Events Leading to This Priority Letter AD

97-12-06 CESSNA AIRCRAFT COMPANY: Priority Letter issued on June 6, 1997. Docket No. 97-CE-35-AD.

Applicability: Model 172R airplanes, serial numbers 17280001 through 17280081, certificated in any category.

Engine Lower Cowling Modification
Figure 1

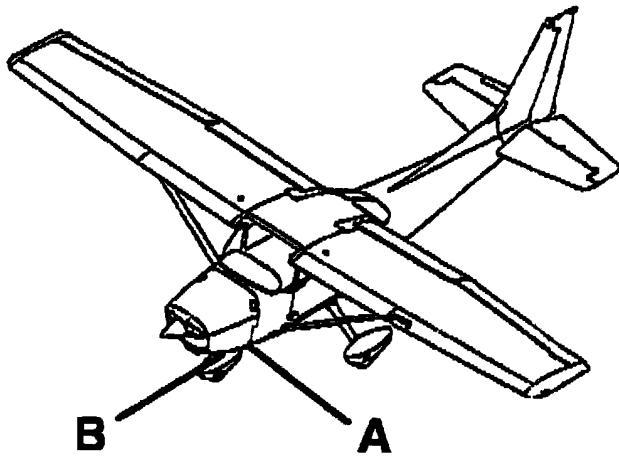
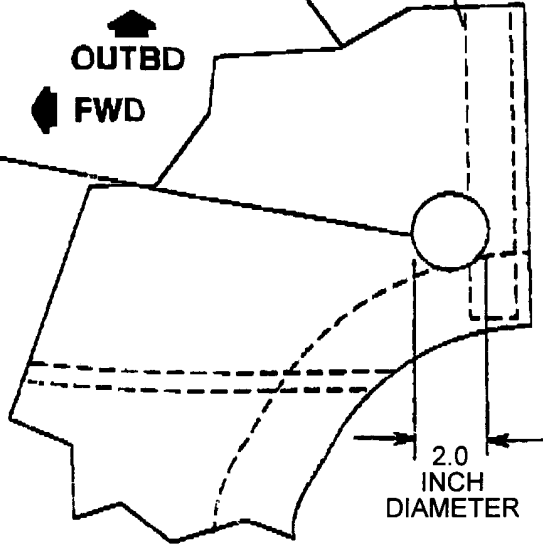
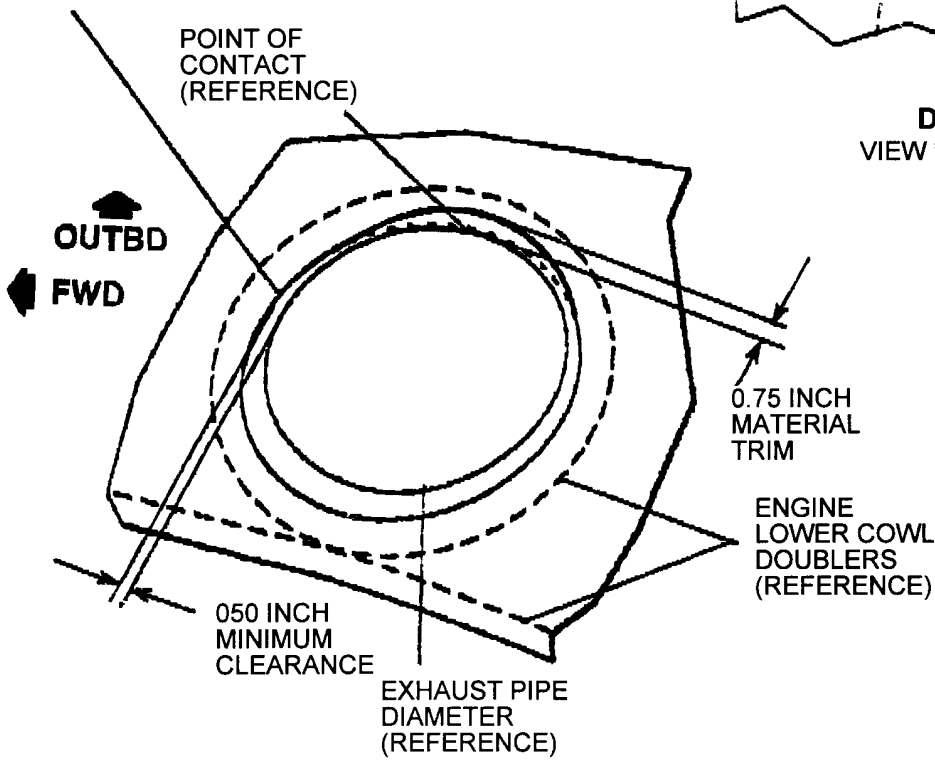
Since an unsafe condition has been identified that is likely to exist or develop on other Cessna Model 172R airplanes of this same type design, this AD requires checking for the clearance between both the gascolator and cowling and the tailpipe and cowling. This priority letter requires modifying these areas immediately if any evidence of rubbing at either location is found or modifying the gascolator to cowling area within 10 hours time-in-service (TIS) if no evidence of rubbing at either location is found. Accomplishment of the modifications is in accordance with Cessna Service Bulletin 97-28-01, if rubbing is evident, or in accordance with Figure 1 of this AD if no rubbing is evident.

(2) If no evidence of rubbing is found, repeat the check in paragraph (a) before each flight, and within the next 10 hours time-in-service (TIS) after receipt of this AD, modify the gascolator and cowling area in accordance with Figure 1 of this AD.

ENLARGE HOLE AROUND THE FUEL STRAINER DRAIN VALVE TO 2.0 INCHES DIAMETER (CONCENTRIC). THE NEW HOLE WILL CUT INTO THE CHANNEL JUST AFT OF THE ORIGINAL HOLE ABOUT 0.50 INCH.

TRIM HOLE AROUND THE EXHAUST PIPE TO PROVIDE MINIMUM OF 0.50 INCH CLEARANCE.

IN AREAS OF CONTACT, ENLARGE TO 0.75 INCH CLEARANCE.
